3.4 Water Level (Flood) Design

The information in this section of the reference ABWR DCD, including all subsections and tables and figures, is incorporated by reference with the following supplements and departures.

Figure 3.4-1 Non-Breaking Wave Force on Vertical Wall

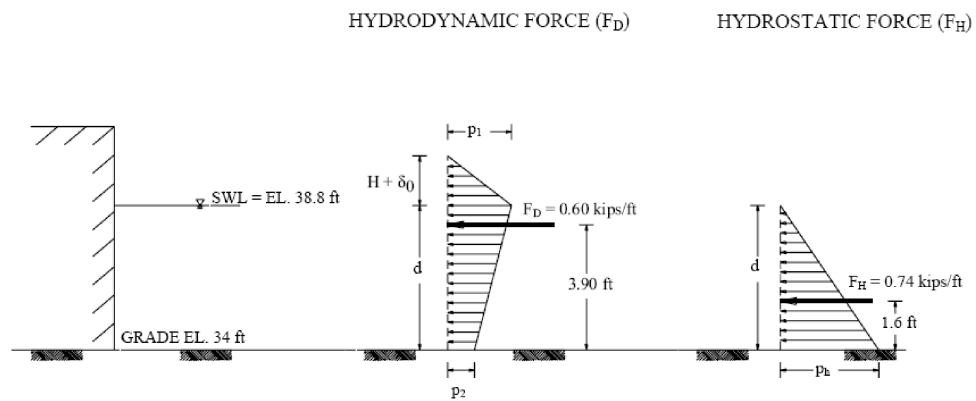
As discussed in Section 2.4S.4.2.2.4.3, the hydrodynamic force due to the wind-generated wave action on building walls has been calculated as shown in Figure 3.4-1.

- Wind generated wave forces as shown in Figure 3.4-1, applicable to above grade portion.
 - Impact due to a 500 lbs floating debris traveling at 4.72 ft/sec.

FL = Design basis extreme flood loads, including the hydrostatic load due to flood elevation at 40 ft MSL, the associated drag effects of 44 psf, impact due to floating debris per Section 3.4.2, and hydrodynamic load due to wind-generated wave action per Figure 3.4-1. Figure 3.4-1 shall only be used to calculate hydrodynamic load due to wind-generated wave action. The weight of the water (above ground) due to the flood loads shall be 63.85 pcf in order to include the effects of suspended sediments in the water.

F_D = Resultant hydrodynamic force (in kips per linear foot) equivalent to the hydrodynamic wave pressure (p_1 and p_2) acting on the structure

F_H = Resultant hydrostatic force (in kips per linear foot) equivalent to the hydrostatic pressure (p_h) acting on the structure

H = Non-Breaking Wave Height(1%) = 2.1 ft

T = Non-Breaking Wave Period = 1.7 sec

d = depth of water at the structure = 4.8 ft

δ_0 = vertical shift of the wave crest and trough at the structure = 1.0 ft

p_1 = hydrodynamic wave pressure at the still water level = 132.8 lb/ft²

p_2 = hydrodynamic wave pressure at the base of the structure = 32.5 lb/ft²

p_h = hydrostatic pressure at the base of the structure = 306.5 lb/ft²
